PROPOSED OFFICE BUILDING

111 MAPLEWOOD AVENUE
PORTSMOUTH, NEW HAMPSHIRE

PROJECT NO: K-0076-019

**TAC SUBMISSION
COMPLETE SET 30 SHEETS**

SITE PLAN

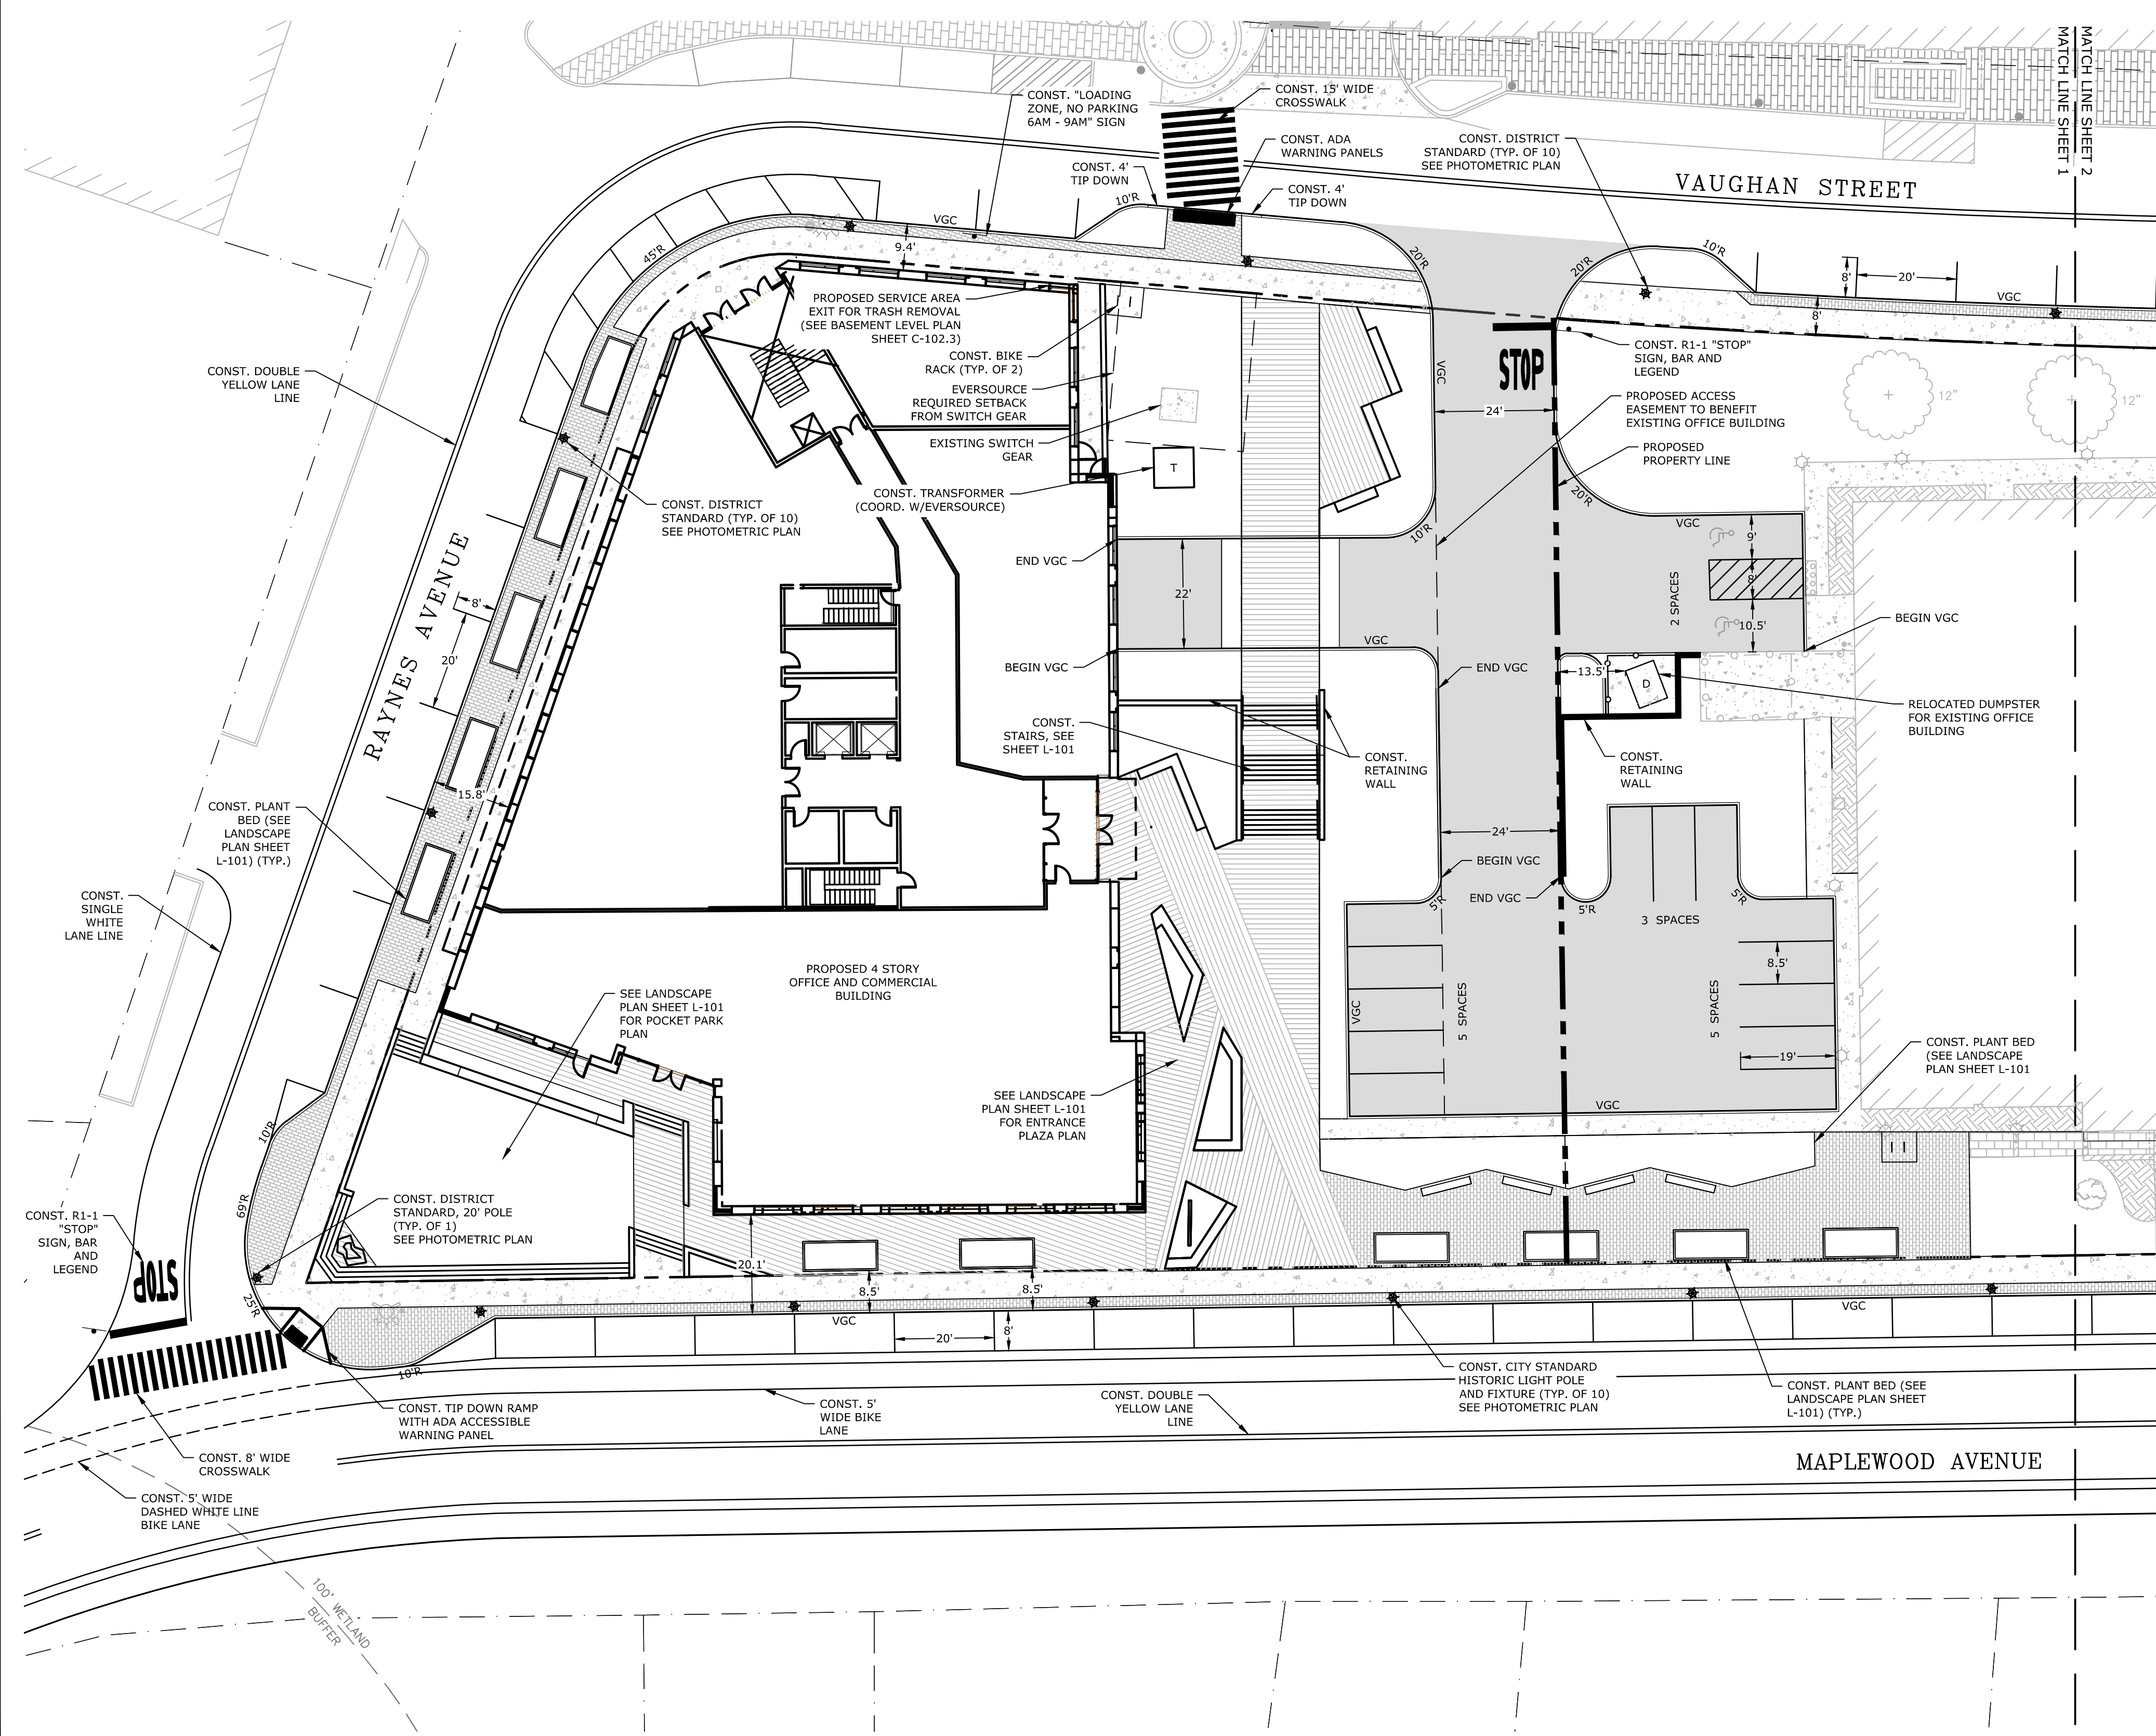
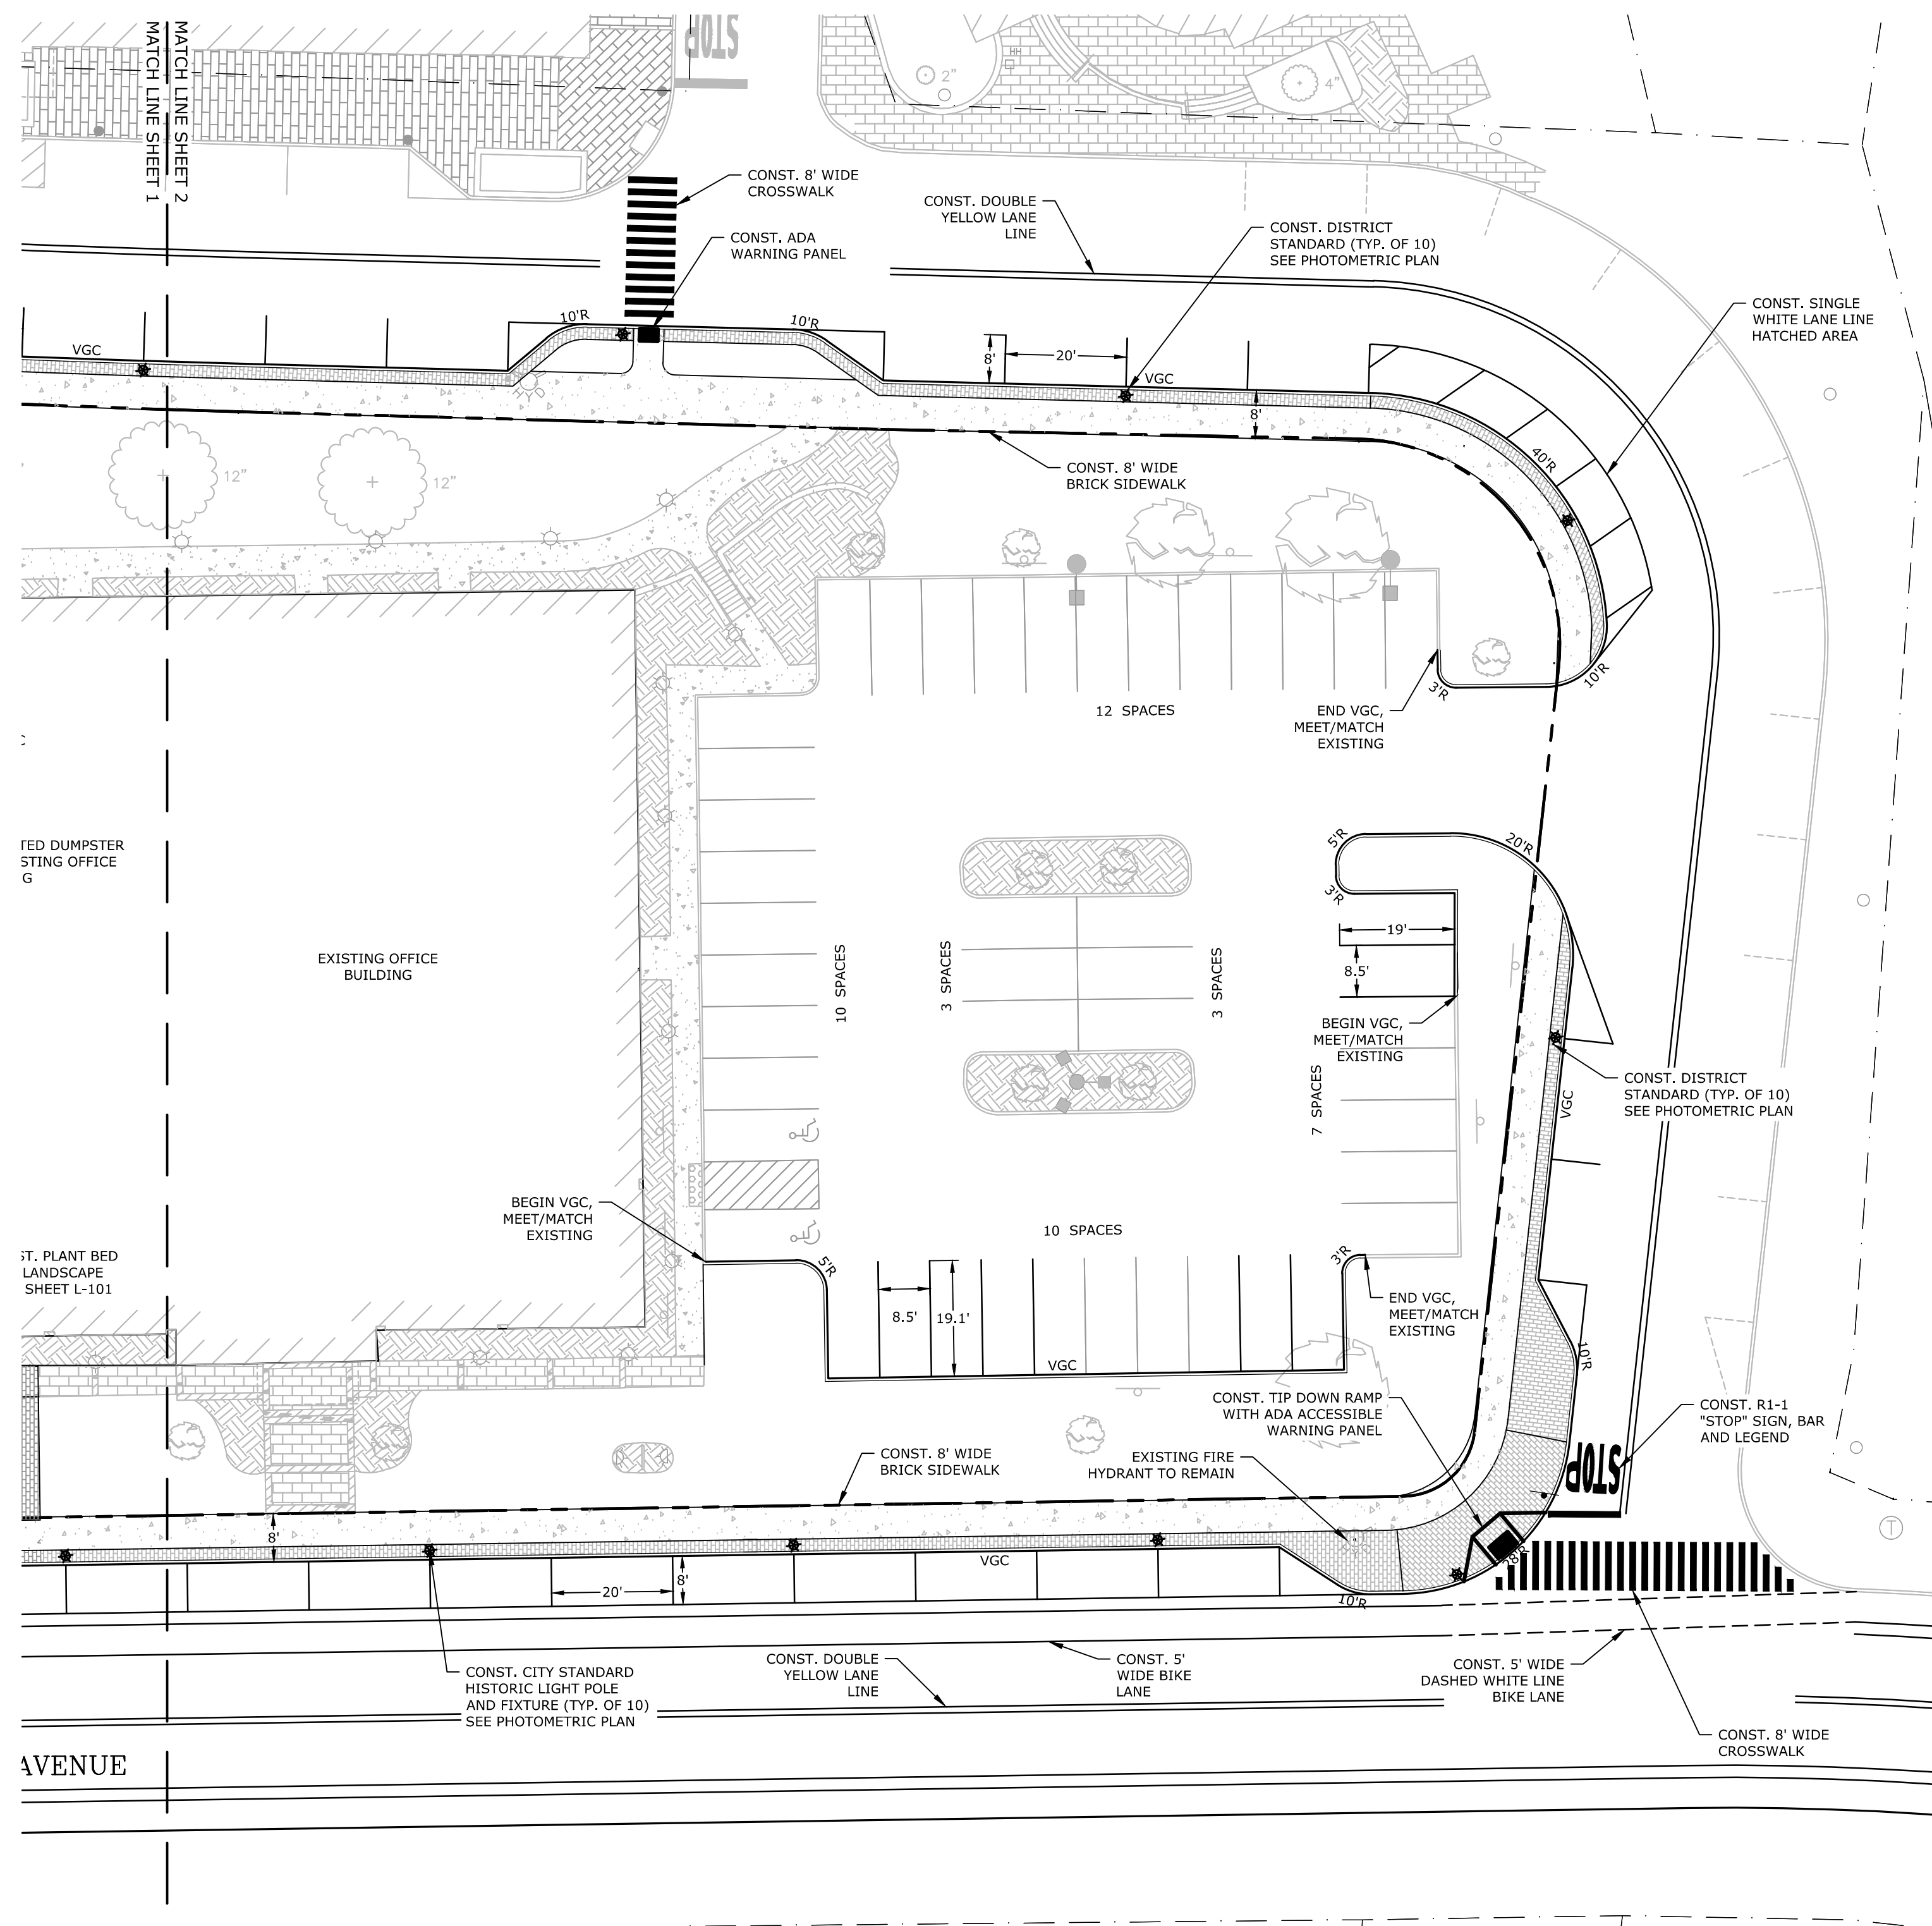
18	Correct proposed number of stories on plan Sheet C-102	The number of stories has been revised on all sheets.	C-102, C-102.1
19	Are the dumpsters intended to be used for use by both properties?	Exterior dumpster shown on the Site Plan is for the existing office building only. Trash from the proposed building will be stored in a trash room located inside the building.	C-102.1
20	Dumpster location needs to be set back at least 10' per zoning and 20' per site plan review regulations. If 20' is not possible, a waiver will need to be requested.	The dumpster meets the zoning setback requirements. A waiver is requested to allow the dumpster to be less than 20ft from the proposed property line.	C-102.1 & Waiver Request
21	The proposed community space should be adjusted to avoid public access easement that does not align with the pedestrian circulation patterns on the proposed alleyway connector.	The proposed community space has been revised to include the entire entry plaza as part of the pedestrian alleyway.	C-102 & Community Space Exhibit

22	The proposed building should be listed as a 4 story building given the 4th story does not qualify as a penthouse.	The number of stories has been revised on all sheets.	C-102, C-102.1
23	Pending HDC approval, the building elevations should be included in the plan set.	Confirmed, the latest elevations submitted to HDC are enclosed with the plans.	Building Elevations
